project:  
**RENOVATIONS TO EXISTING COMMERCIAL BUILDING**  
client:  
**BRAVE CONTROL SOLUTIONS**

title:  
**SECOND FLOOR PLAN**

Permit Set: 1785 Walker Rd. P# 20-254038 R# 020-240-01400

**A1.2**

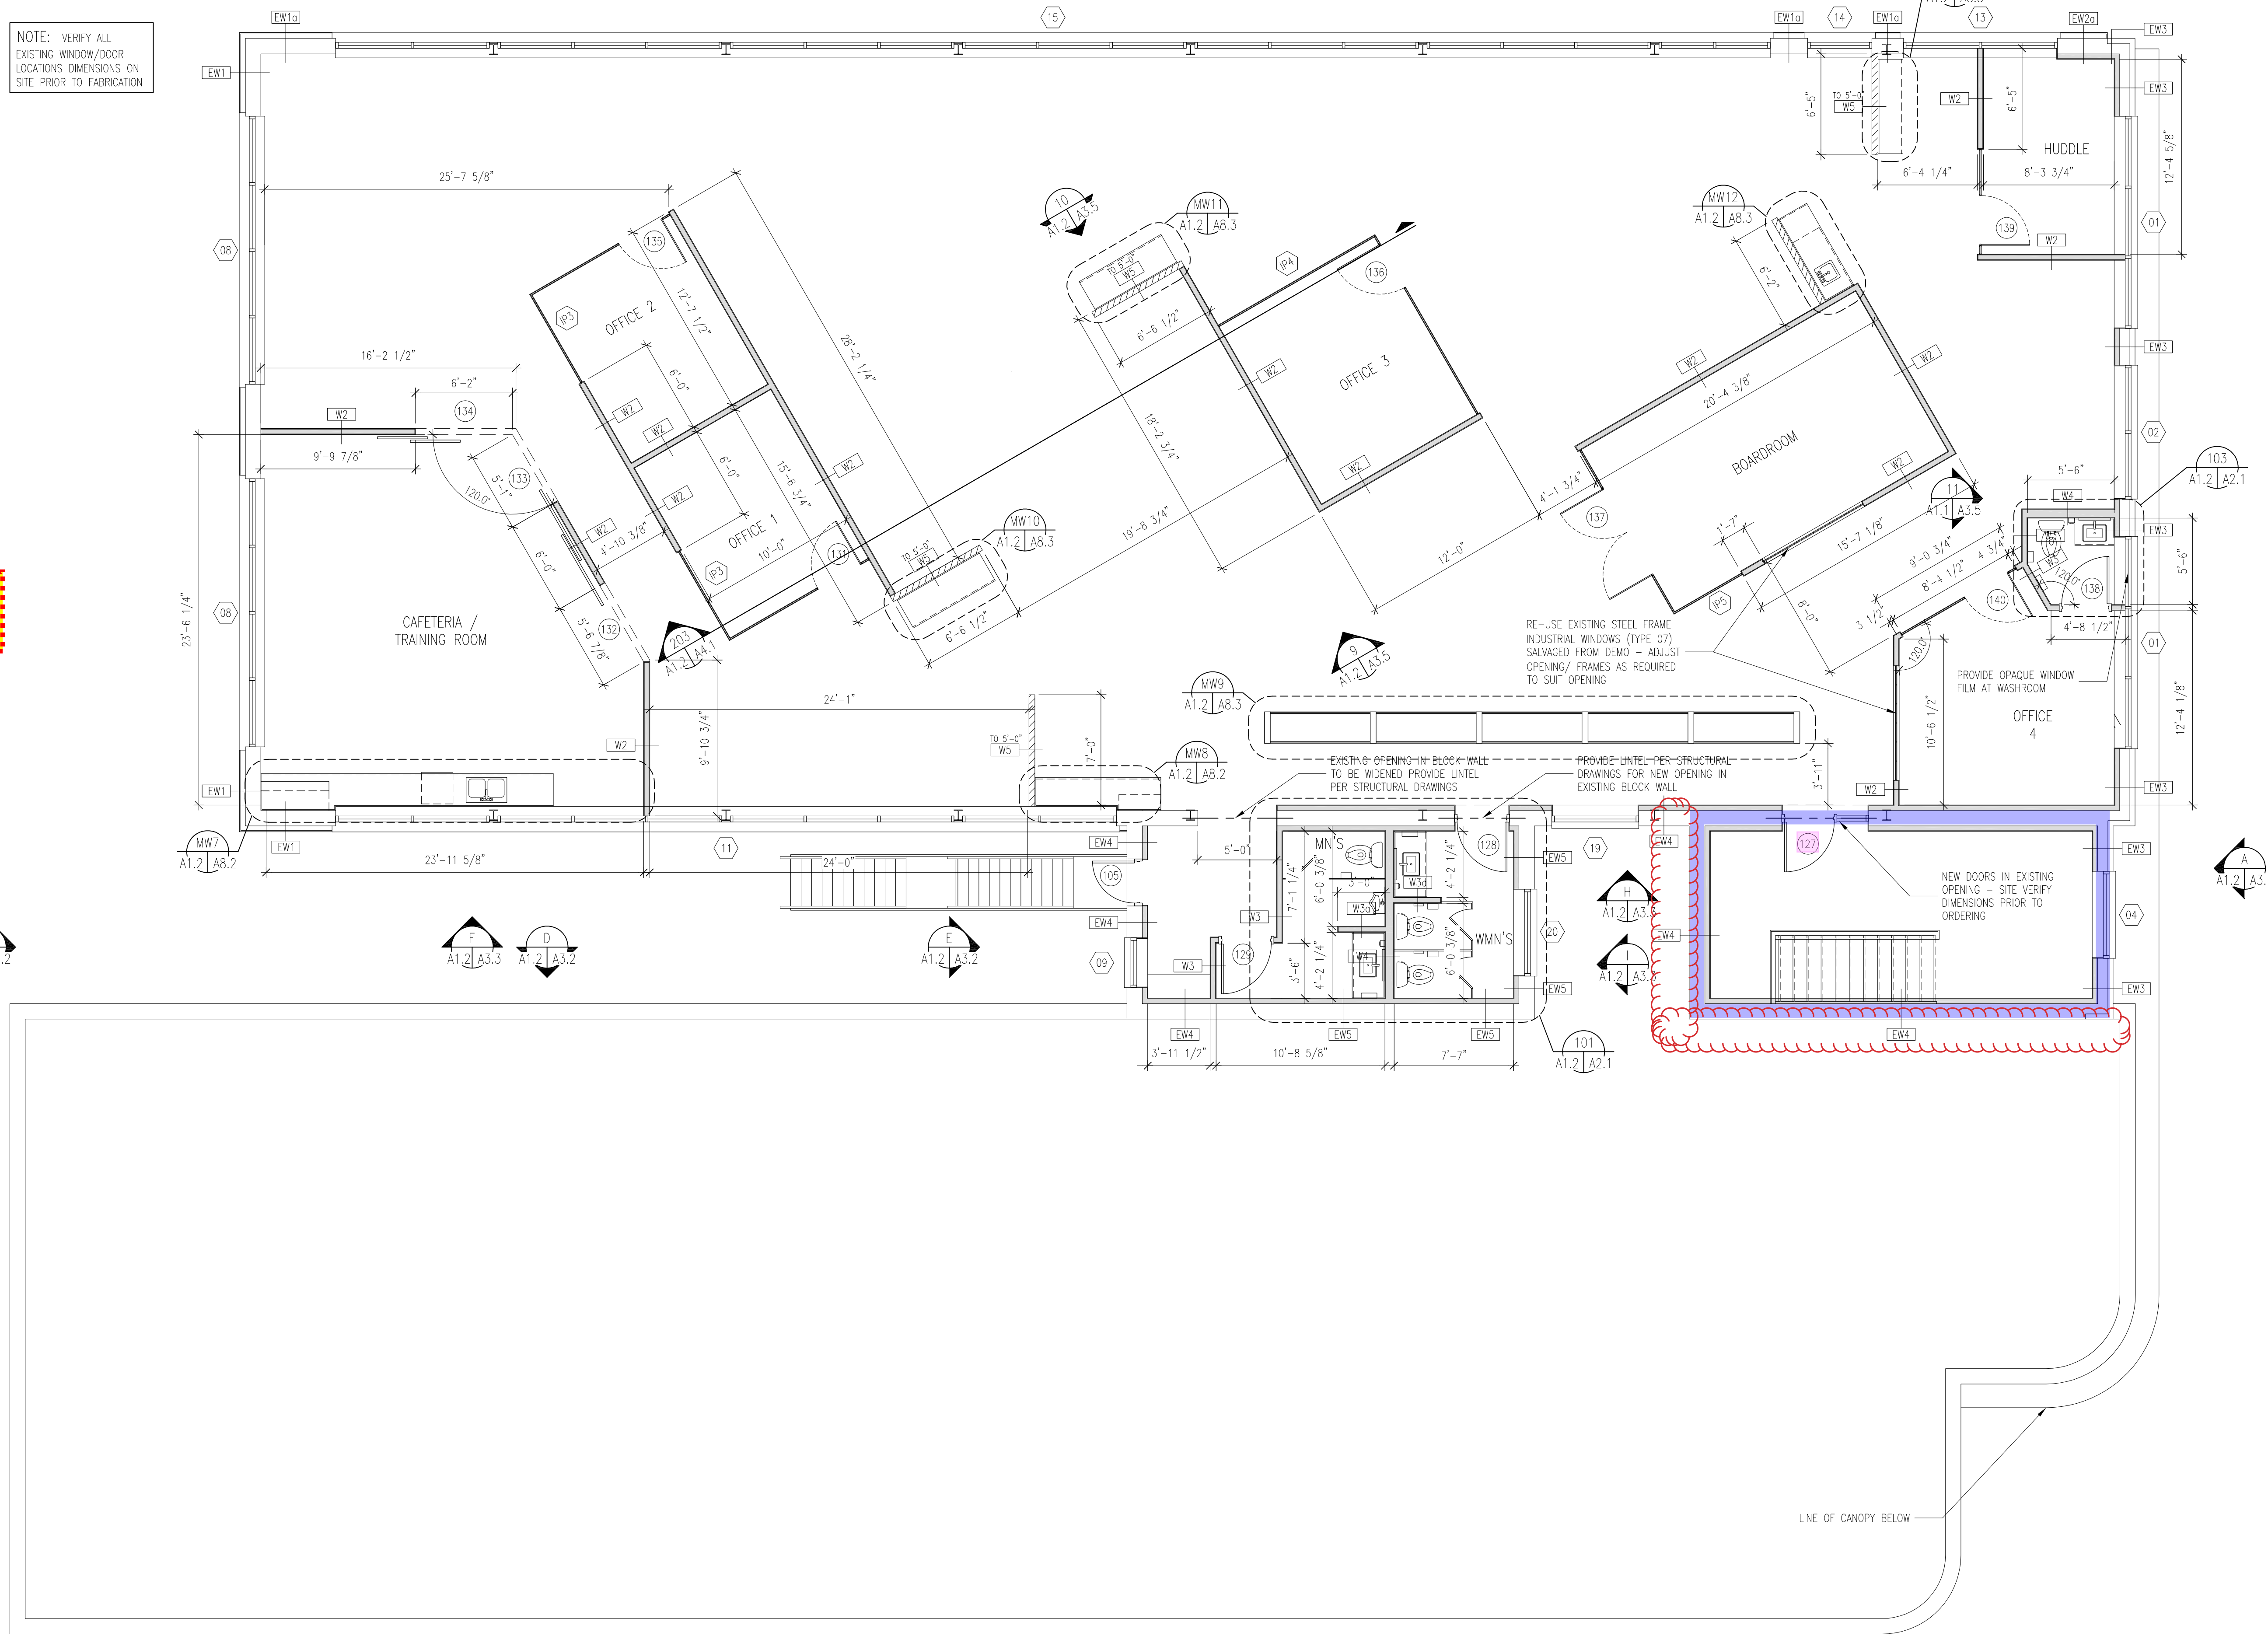
PORTABLE FIRE EXTINGUISHERS  
Shall be installed in conformance with Part  
6 of Division B of the Ontario Fire Code.

Required One Hour Fire Rated Separation  
Required One Hour Fire Rated Separation - 'Exit Enclosure'
